Re: *Design Review of Sample Building Hotel / Residential Tower*

1.00 Design Review Summary and Overall Risk Assessment

Figure 1 – Example of two-stage joint at precast panels. From: “CHMC’s Best Practice Guide – Architectural Precast Concrete Walls – Overview”

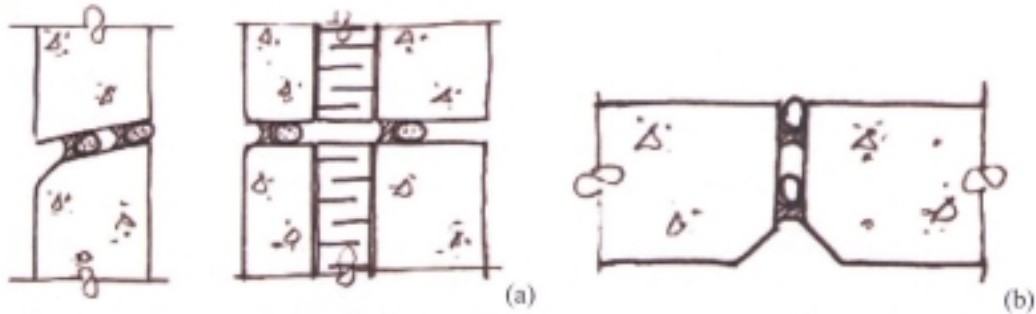
A third-party envelope consultant will provide input on the final design, and a two-stage sealant joint (e.g. similar to the design intent outlined in Figure 1 below is being considered) is being considered. The current drawings (e.g. shown in Figure 2 below) show only a single sealant/backer rod application.

Figure 2 – Window to Precast Panel Jamb Detail from Sheet A6.02/02. One line of sealant and backer rod is currently called out in the drawings

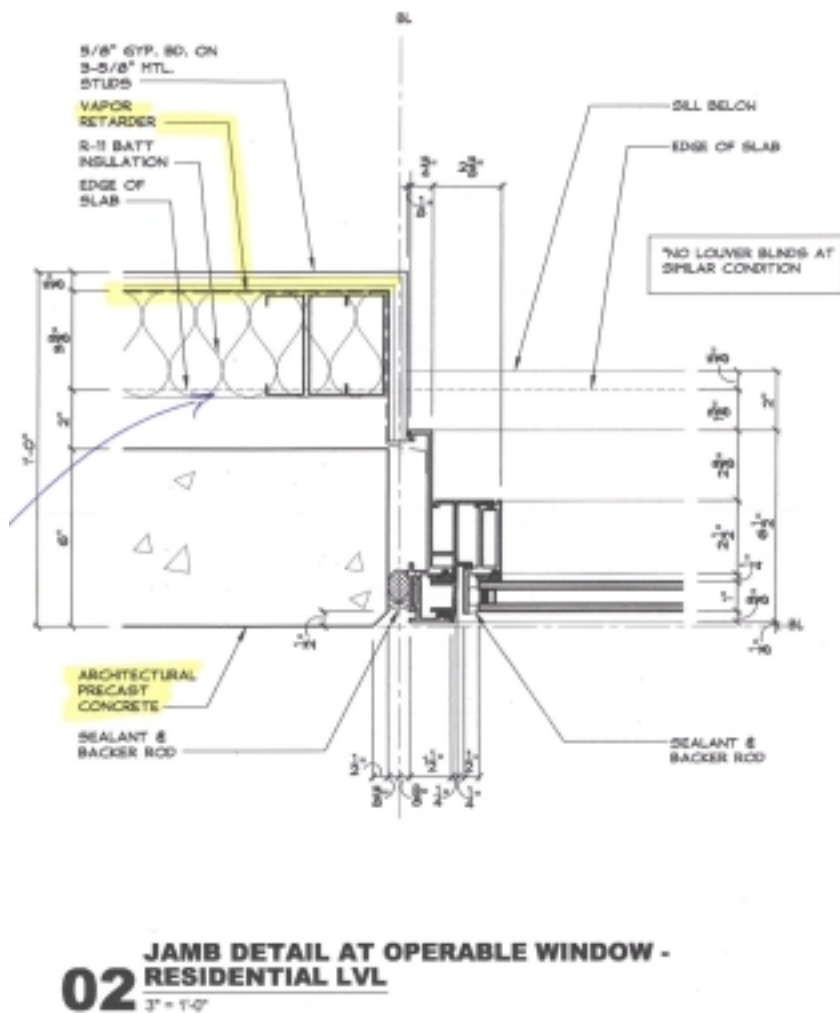
The air barrier at the south/west elevation is not clearly defined in the current drawings. Similar to the discussion in 4.30 above, two lines of defense at the precast panel joints can work to control air leakage. Without the two lines of

sealant, the design relies on the integrity of the punch windows and interior gypsum to control air leakage.

Given the stage of shop drawing development, and involvement of Sample Associates, mSolve is comfortable that air leakage through the precast envelope will be addressed. Identical to the issues addressed above, we request a copy of the final shop drawings that show how air leakage will be controlled on the precast members.
